PLANNING DIVISION STAFF REPORT

November 13, 2023

Project Address: **405-407 & 431 W Gorham Street, 408-430 W Johnson Street, and 304-318 N Broom Street** (District 3 – Alder Verveer)

Application Type: Demolition Permit, Land Use Restriction Agreement, Zoning Text Amendment, Zoning Map Amendment, Conditional Use, and Certified Survey Map Referral

Image 2: The development's four building 'expressions' (masses)

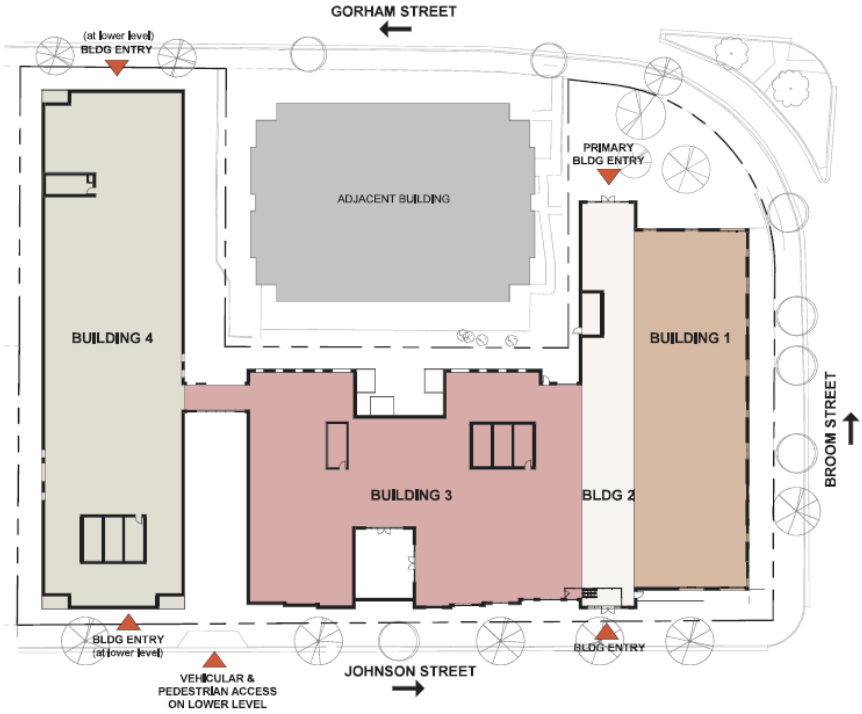
Staff have a few concerns related to the building's design. The first, which was raised at the Urban Design Commission meeting on November 1, is the lack of ground-floor entrances along the entire 185-foot N Broom Street façade as well as roughly 230 feet of the W Johnson Street frontage. Staff note that the UDC at their aforementioned meeting on November 1, added a condition that an additional connection to the street be incorporated along the W Johnson Street frontage. Staff however still believe that an additional entrance is needed along the N Broom Street frontage noting that, if the Building 1 were a stand-alone building, that a primary entrance oriented to the primary abutting street would be required. (Staff acknowledge that an entrance facing W Gorham could meet this requirement if it were located at or wrapped the north corner).

The second concern is the significant blank wall expanse located on the upper floors of the southwest façade of Building 2 (see Sheet 36 "Elevation Promenade Bldg 3" in the submitted materials). The units on the first eight floors of that façade have multiple windows while the units on Floors 9-14 have none, despite the fact that the upper floors would actually afford a view and be less obscured by the adjacent 12-story Equinox building. When brought up to the applicant, they responded with the following, "*As presented to and approved by UDC, this area on the back side of building 2 is predominately bathrooms on the floors 9-14. This is in the narrow section of the building 2 and the design pushes the living room/kitchen/bedrooms to the Broom- and Gorham-facing facades to maximize views. This section of the building is also effectively screened from view by the Equinox as the building is pulled back from the street frontage and the two buildings are closest together along this property line.*" To this end, Staff note that the northwest façade of Building 2 is set approximately 50 feet further back from W Gorham Street than the same façade of the adjacent 12-story Equinox building meaning the views of the section of blank façade from the public right-of-way will be extremely limited.

Image 4: Downtown Height Map in MGO Section 28.071(2)(a). Left: the current version (with the area proposed to be changes indicated with a dashed circle). Right: the proposed version with the change made.

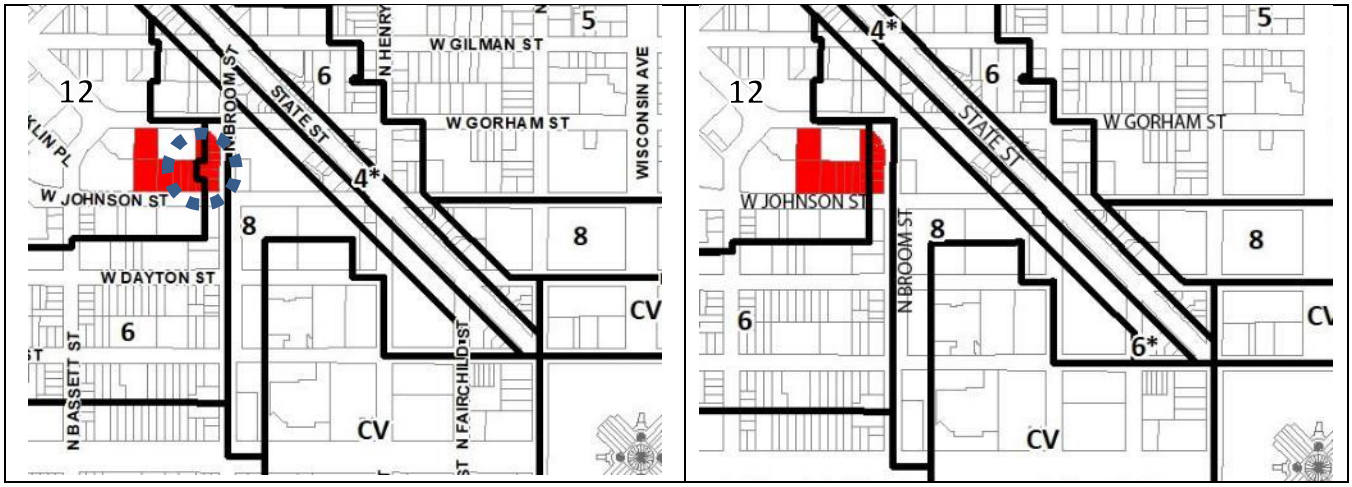
Relatedly, a zoning text amendment (Legistar File ID 80308) is working its way through the City's committees and commissions which would amend the Downtown Height Map in MGO Section 28.071(2)(a) related to in the North Broom Street area. (See Image 4 on the following page) It would straighten the dividing line along N Broom Street between allowable six (6) stories and twelve (12) stories on the downtown height map. The previously mapped building height lines jogged to follow lot lines that existed when the map was created. The proposed development will combine the adjacent lots making the jogged line unnecessary. This would bring the Zoning Code's building height map in line with the height recommendations of the Downtown Plan.

As explained in the previous section, the proposed development exceeds the maximum number of stories allowed by the Zoning Code due to the fact that the City of Madison has granted funding in the form of a below-market value land sale to support the affordable units. That said, Staff believe the 8/15 stories to be consistent with MGO Section 28.071(2)(a)2.a. as the proposed building remains at or below the maximum height in feet in Table 28E-3. (i.e. 88 feet for a six-story building and 172 feet for a 12-story building). With the proposal, the eight-story mass is roughly 85 feet in height and the 15-story masses, even with the rooftop mechanical projections, is roughly 160 feet tall. (Staff note that the buildings, at its tallest, lies just below the Capital Height Projection Limit.)
